**January 8, 2018**  
**BOARD OF COUNTY COMMISSIONERS**  
**ORANGE COUNTY, FLORIDA**  
**Y18-725-TA / ADDENDUM # 2**  
**EASTERN REGIONAL WATER SUPPLY FACILITY IMPROVEMENTS PHASE IIIB**

**Bid Opening Date: January 25, 2018**

12/20/2017 4:17:48 PM - P:\I\ER\10034\200-10034-11005\CAD\SHEETFILES\403 WIRING DIAGRAMS DWG - REINEFELD, AURORA

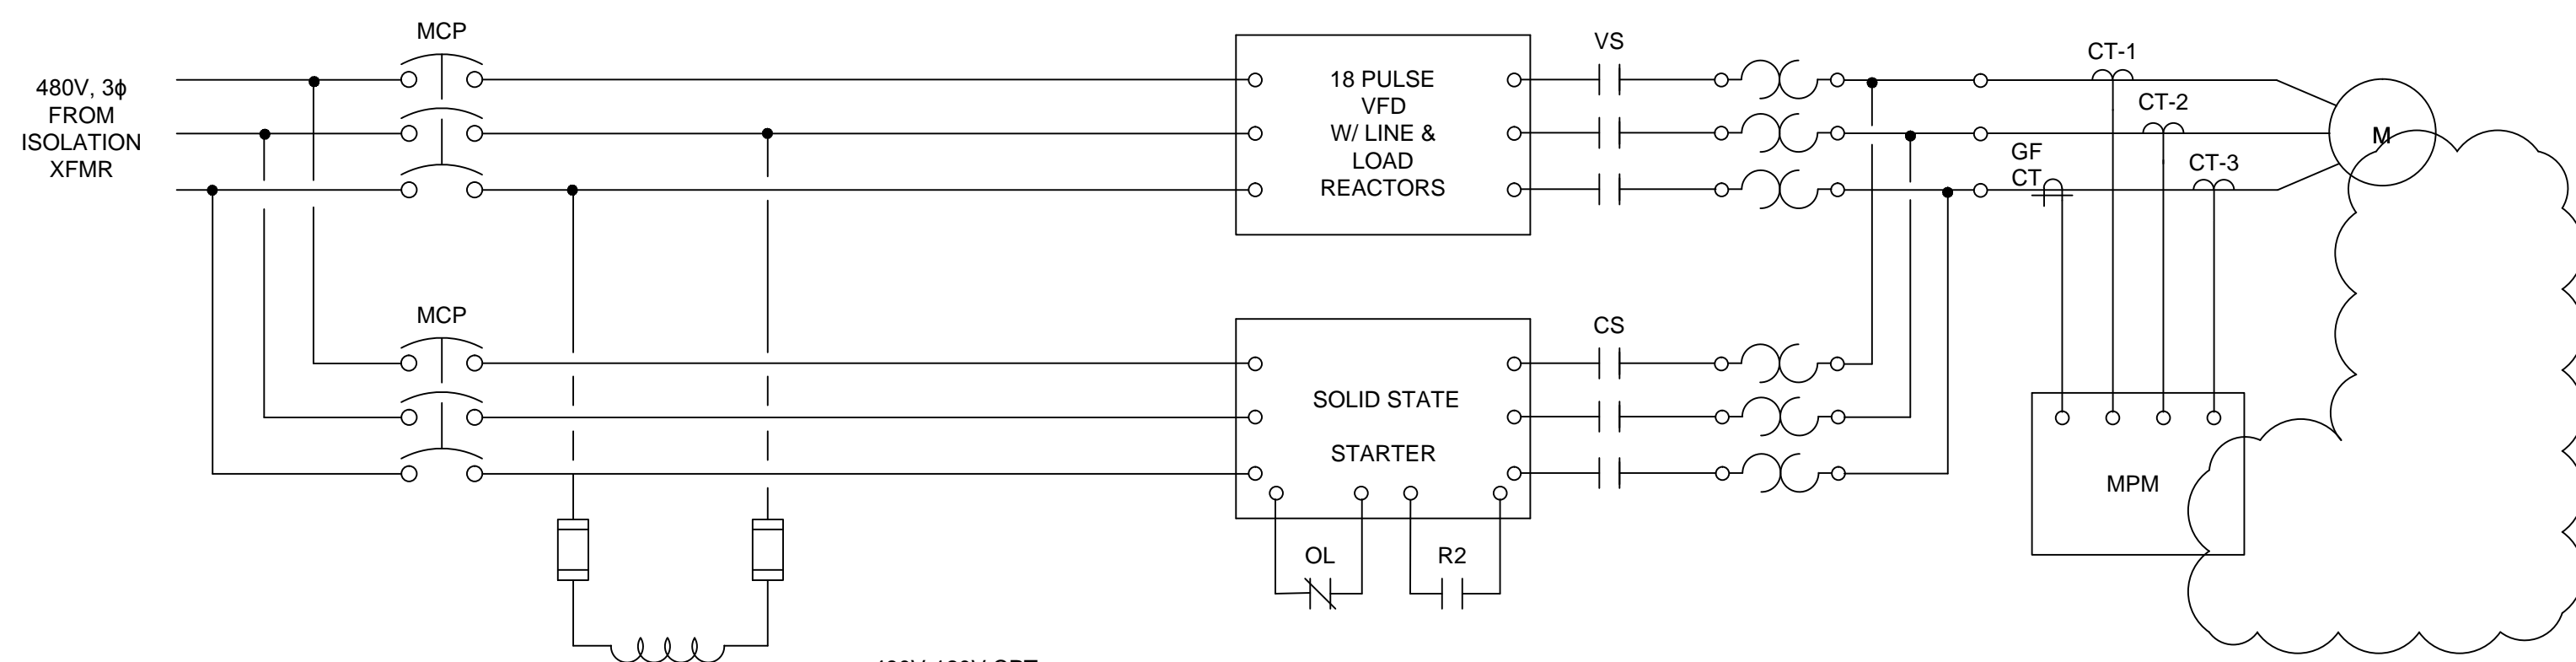
- 3. Drawing Sheet E403, Replace Drawing Sheet E403 Wiring Diagrams with the attached Revised Drawing Sheet E403 Wiring Diagrams.**
  - 4. Drawing Sheet I309, Delete Note No. 1 in its entirety.**
- E.** All other terms, conditions, and specifications of the IFB remain unchanged.
- F.** The Bidder shall acknowledge receipt of this addendum by completing the applicable section in the solicitation or by completion of the acknowledgement information on the addendum. Either form of acknowledgement must be completed and returned not later than the date and time for receipt of the bid.
